Supplement to

MAJOR HAVOC™

Conversion Instructions for Tempest™ (TM-267, 1st Printing)

The following changes affect Figure 17–Deflection PCB Schematic (Version 4).

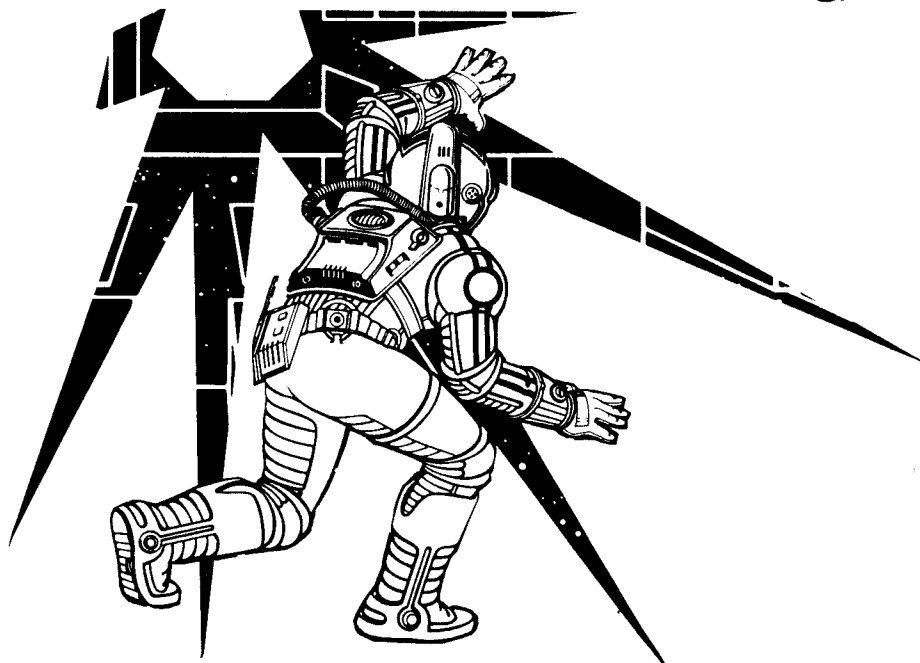
- Page 43.** Delete the two 1N4002 diodes from transistors Q102 and Q103.
- Page 43.** Add two 1N4002 diodes between the emitter and collector of transistors Q705 and Q706 as follows:
